# **FINAL DRAINAGE PLAN**

## **THE RIDGE AT LORSON RANCH**

**FILING NO. 1: SF 22-004**

**JANUARY, 2022**  
**REV. MARCH, 2022**

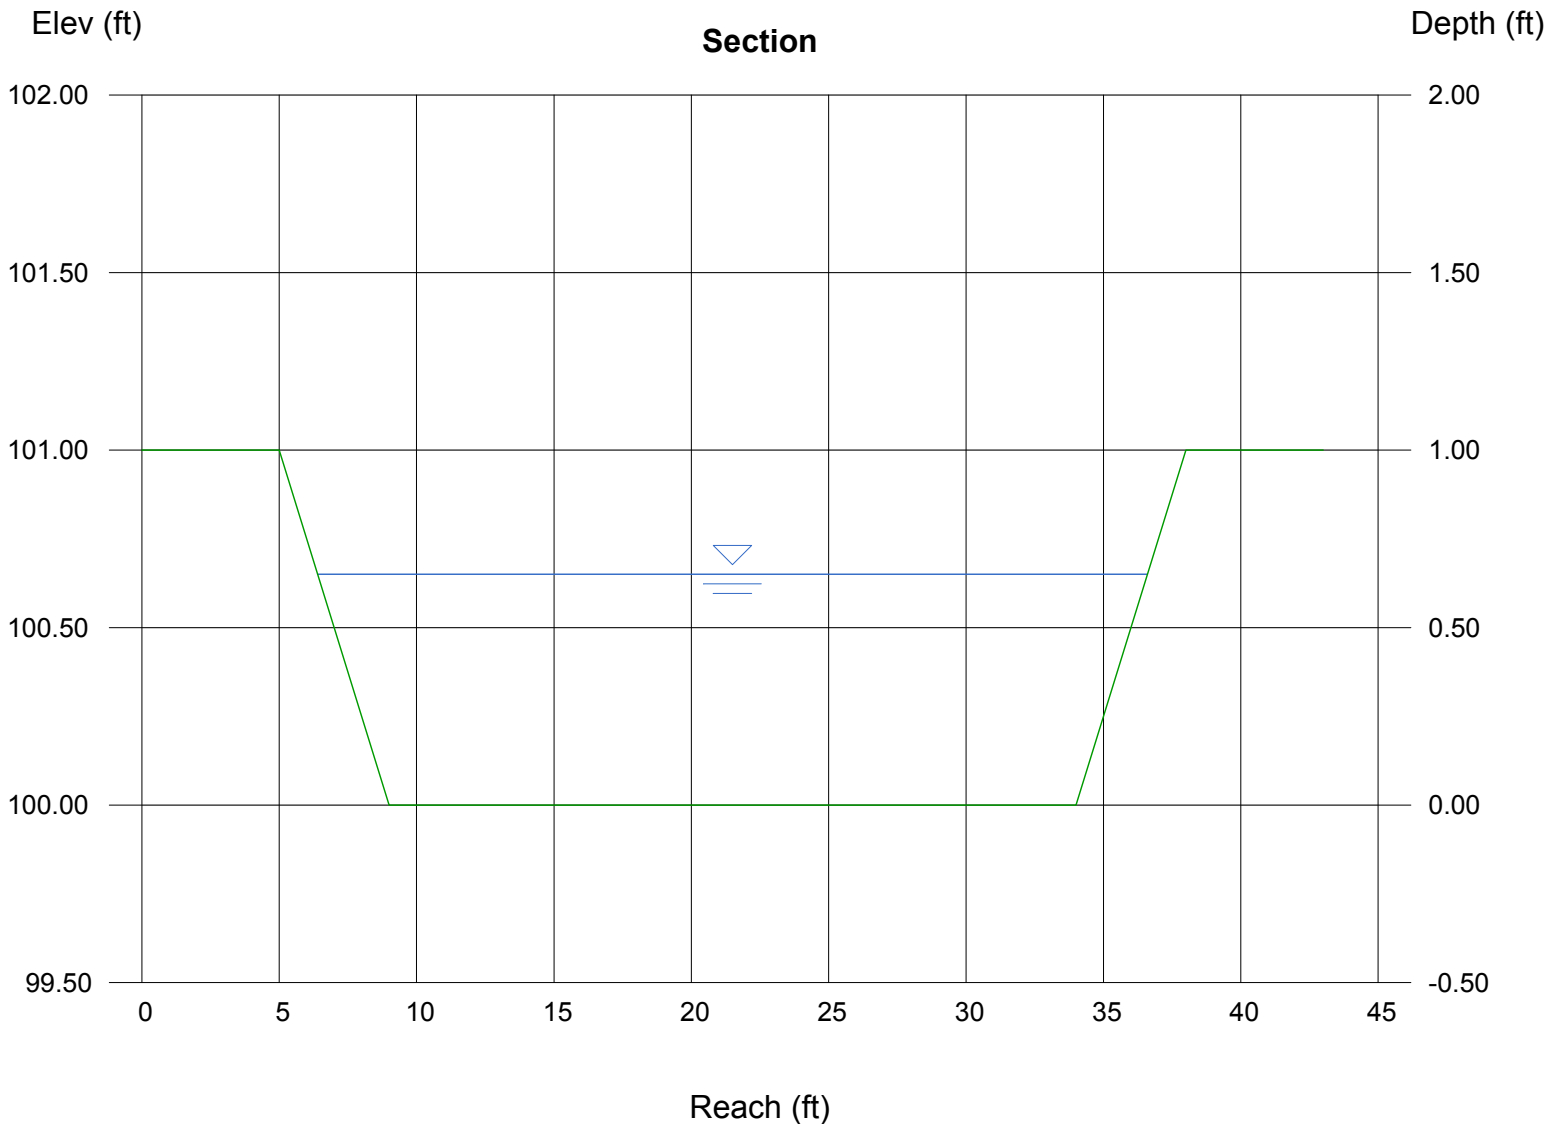
Velocity is high. Add lining/reinforcement to swale.

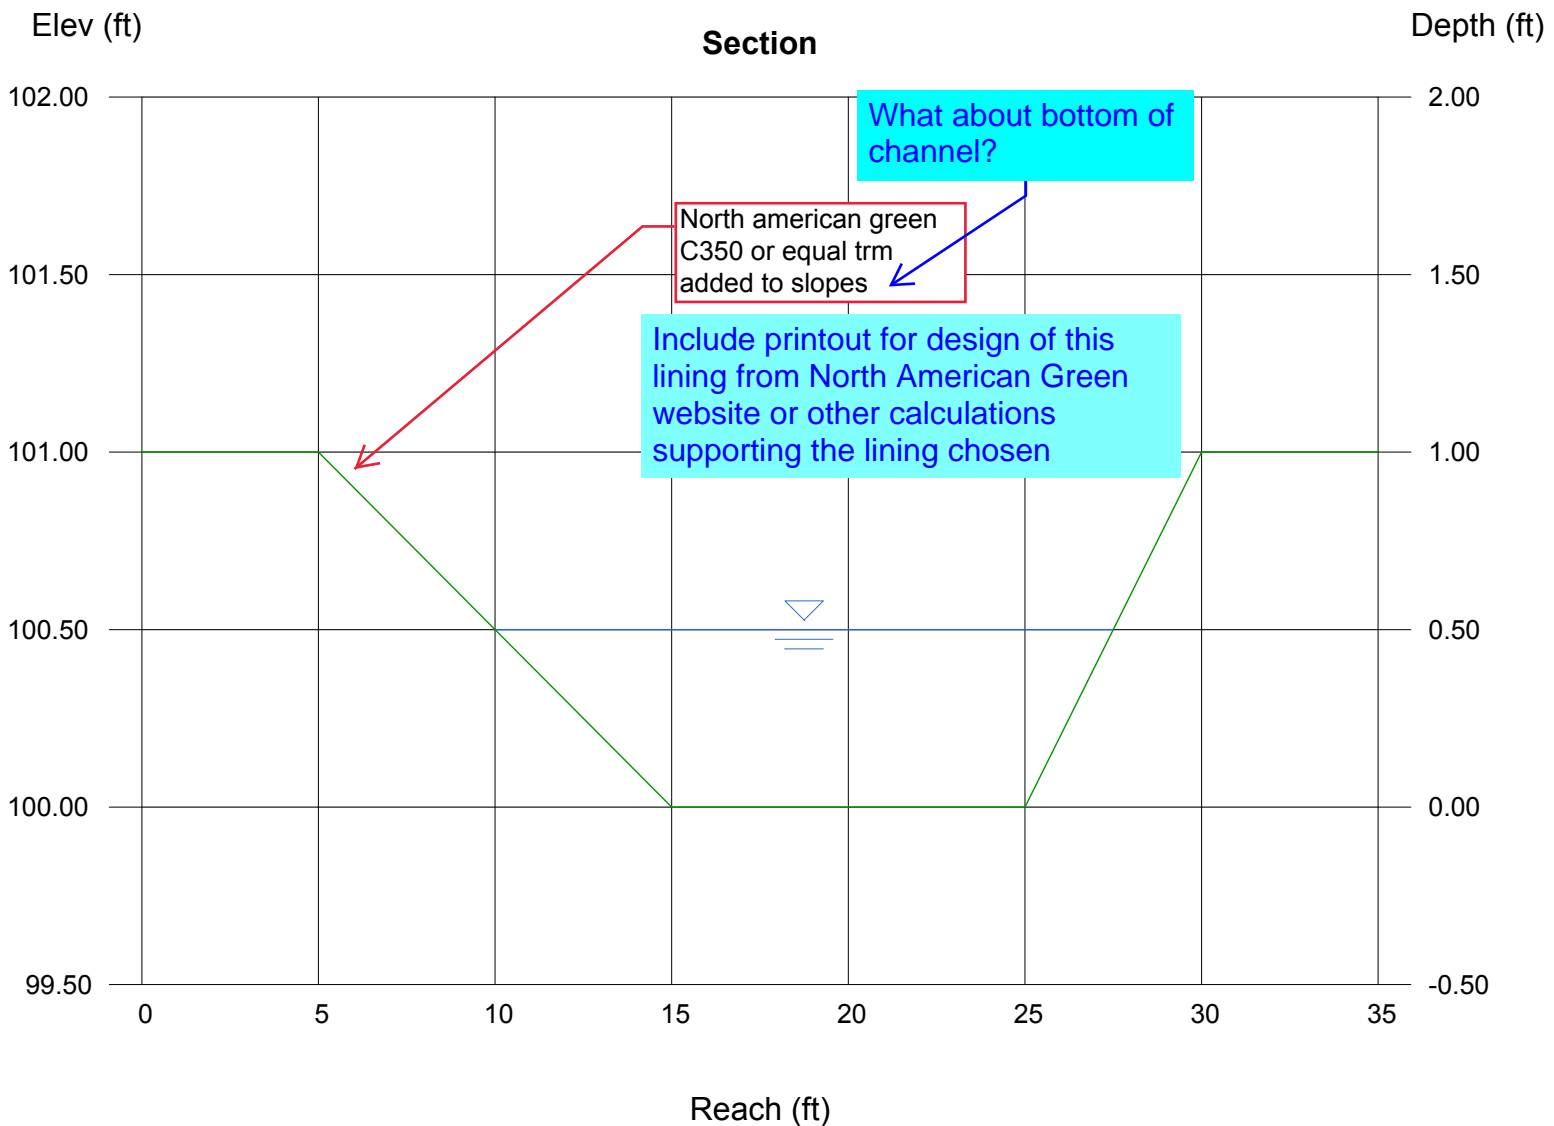
Per section below, one side is 5:1, not 10:1. Please revise design section.

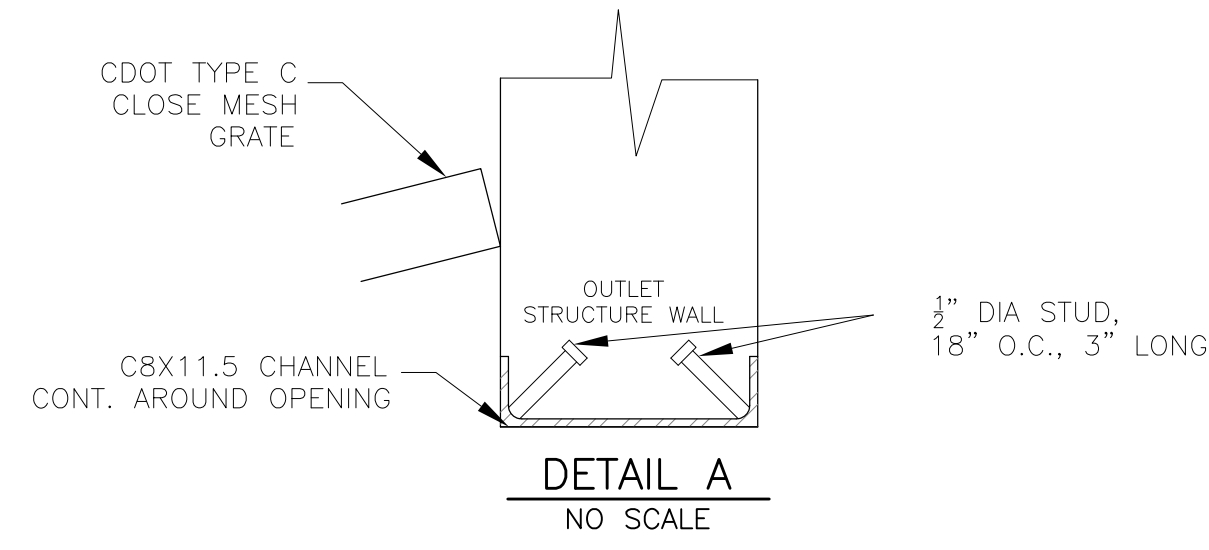
Please include calculation for riprap sizing for spillway

DATE:  
JULY, 2021  
PROJECT NO.  
100.064  
SHEET NUMBER  
**C9.3**  
TOTAL SHEETS: 21

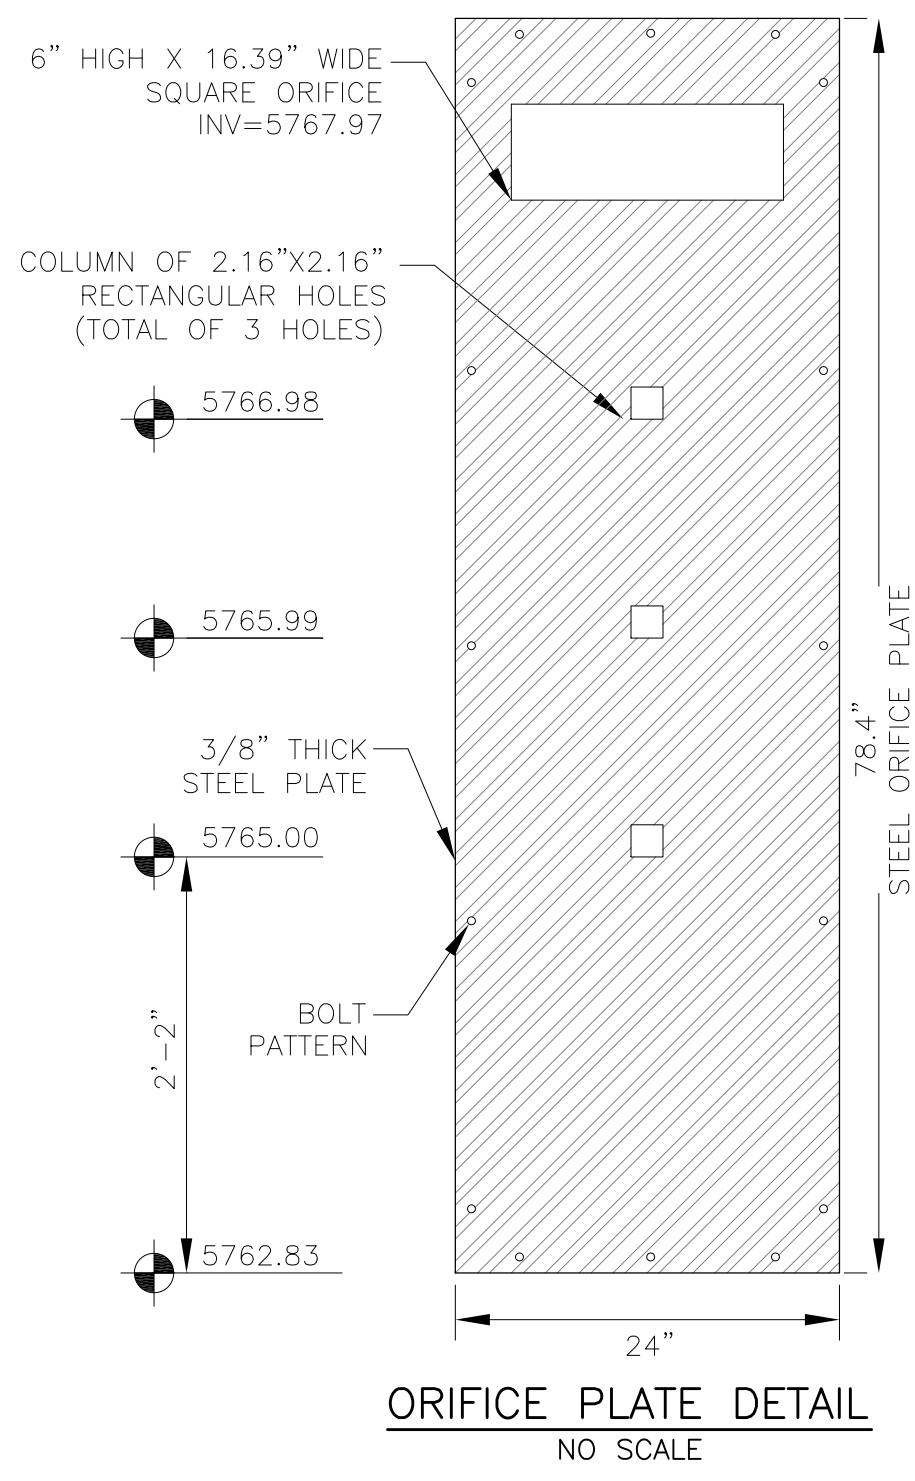
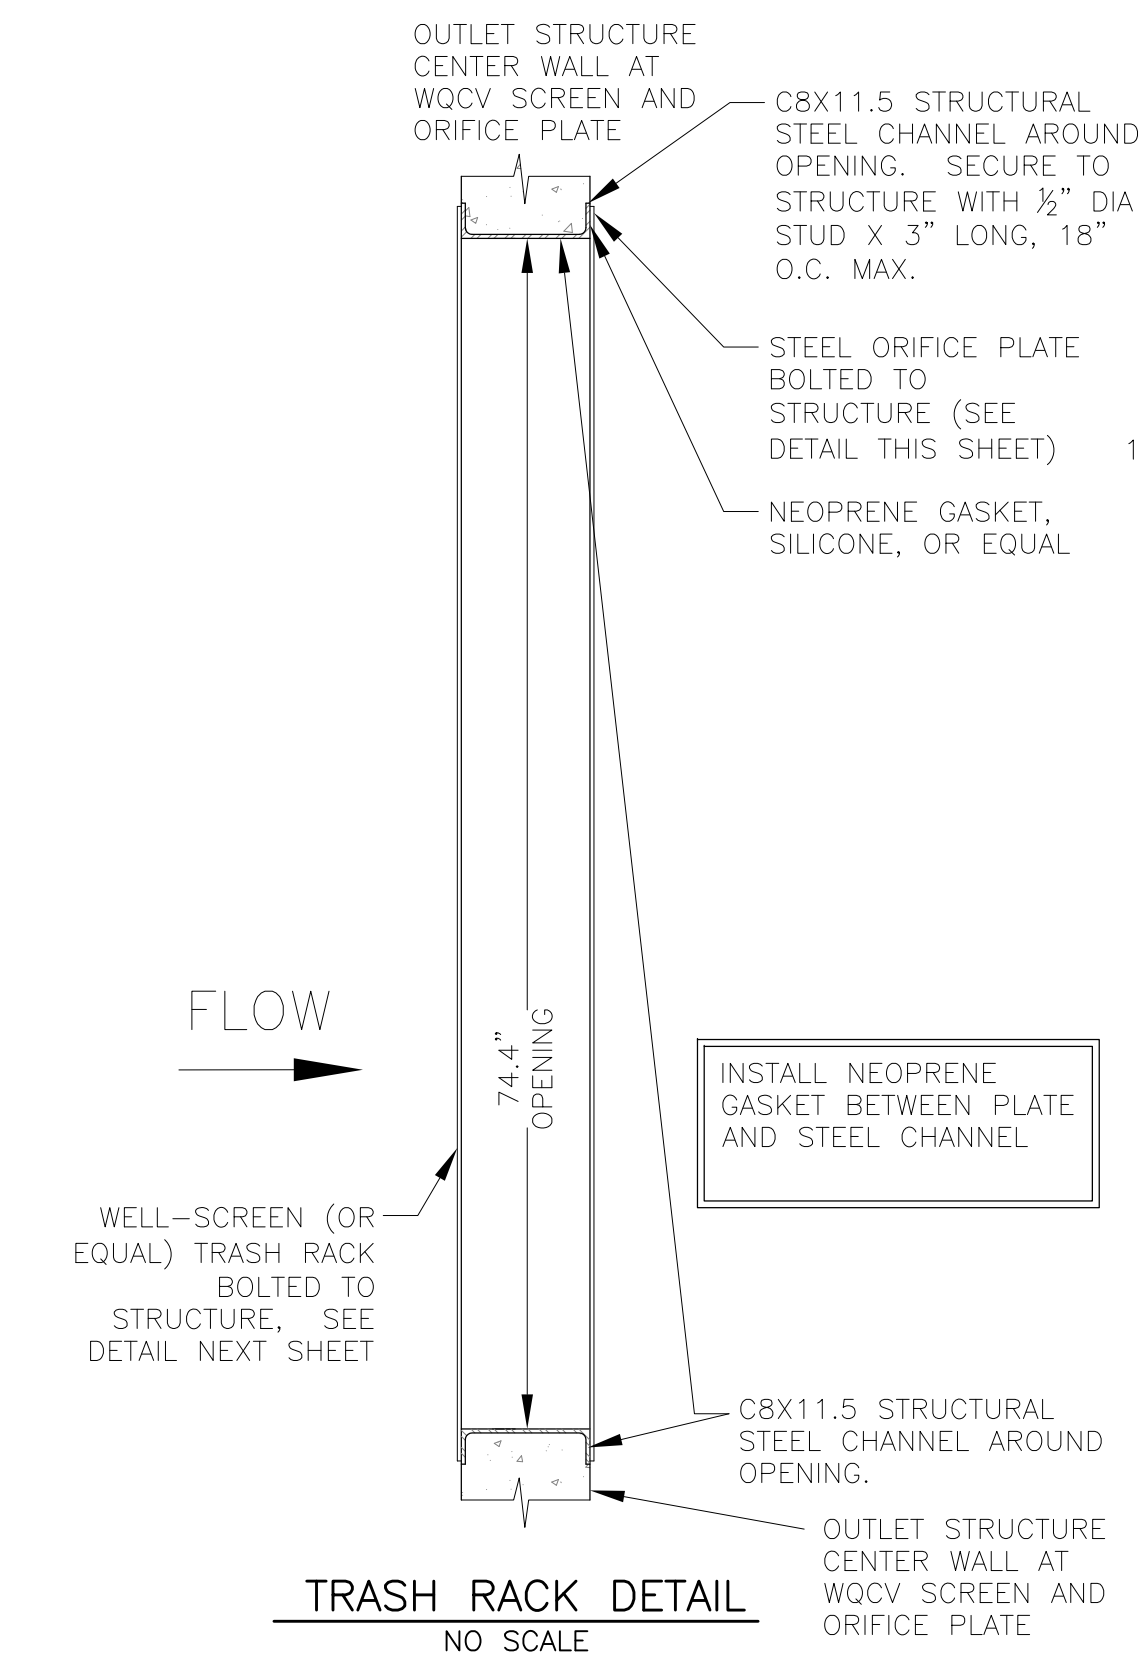
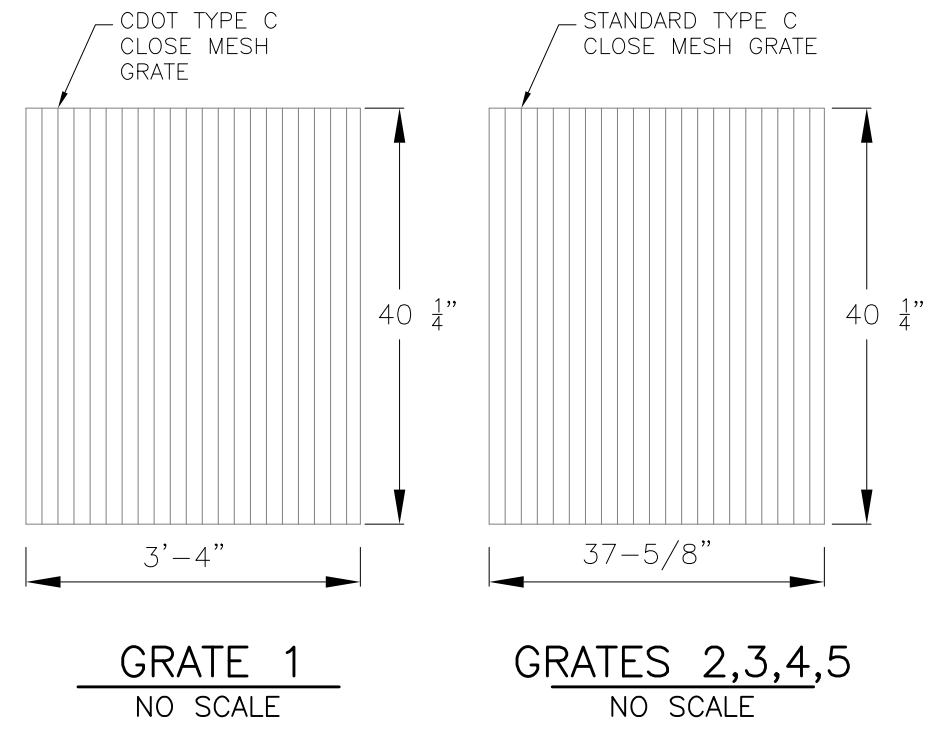
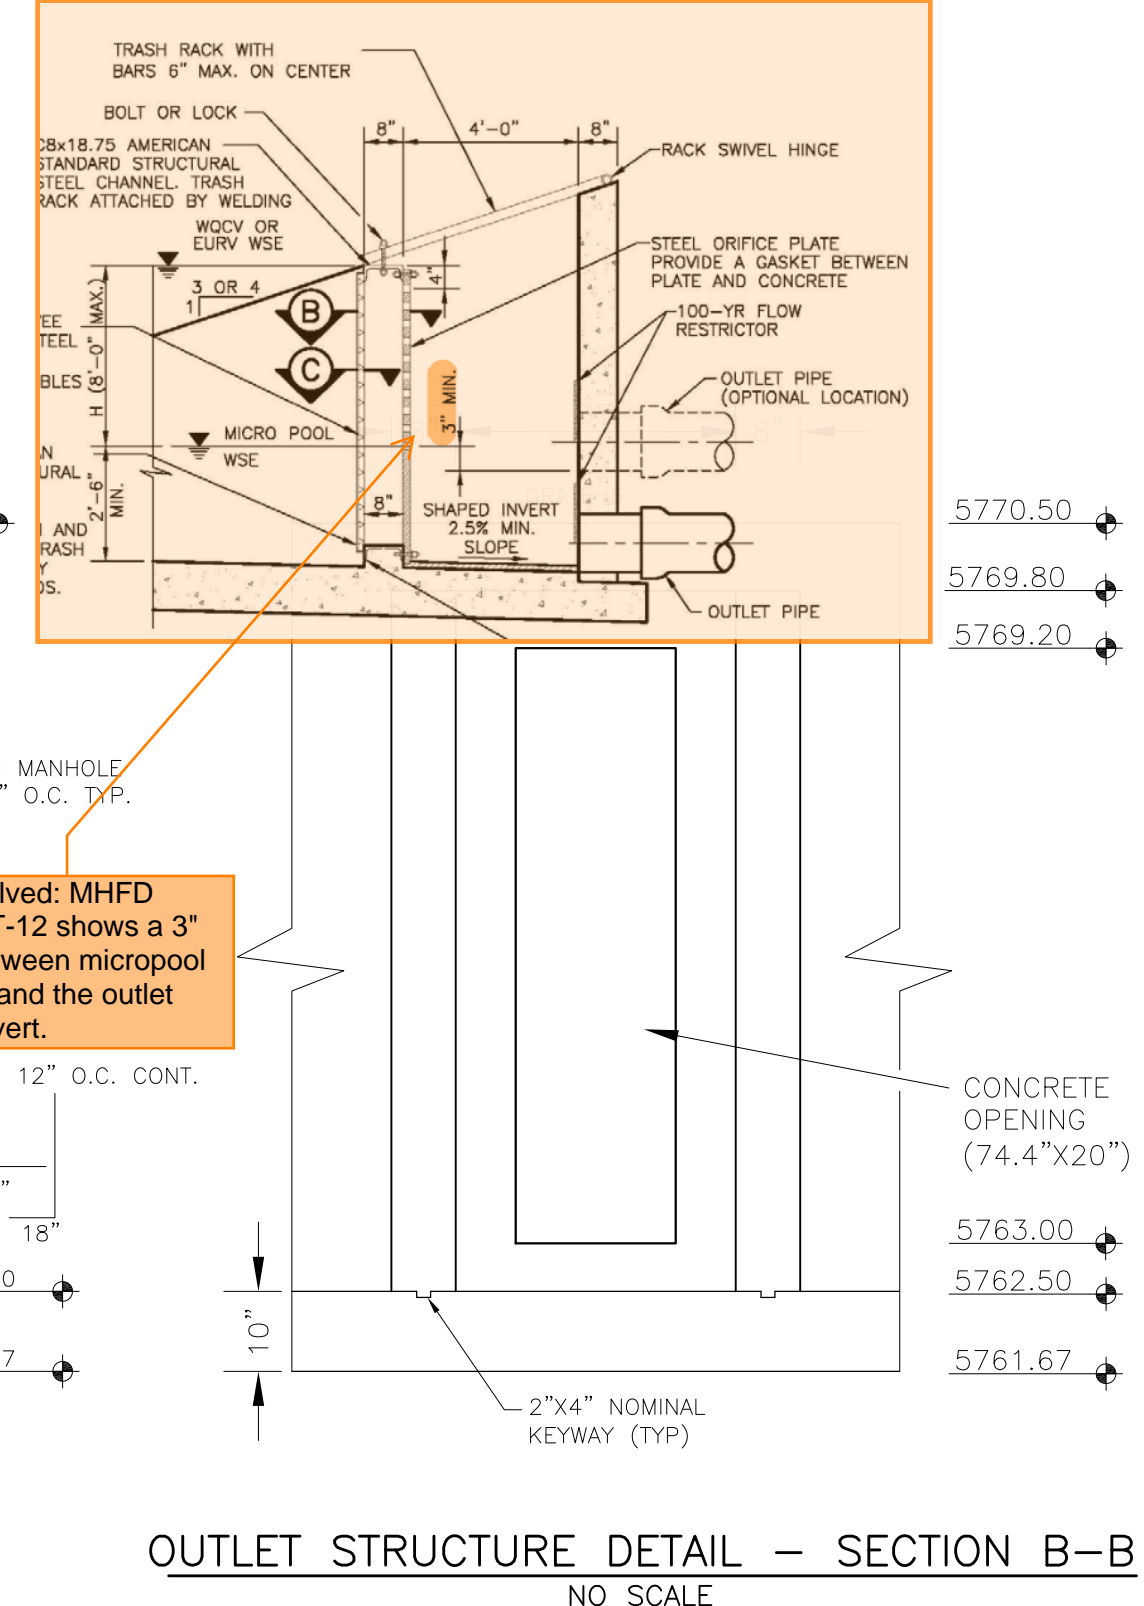
Unresolved Comment:  
Sheets C9.3, C9.4, and C9 need to be included  
in the GEC Plans or the CD's so our SW  
inspectors can see them in the field. Our SW  
inspectors do not look at drainage reports for  
drawings.
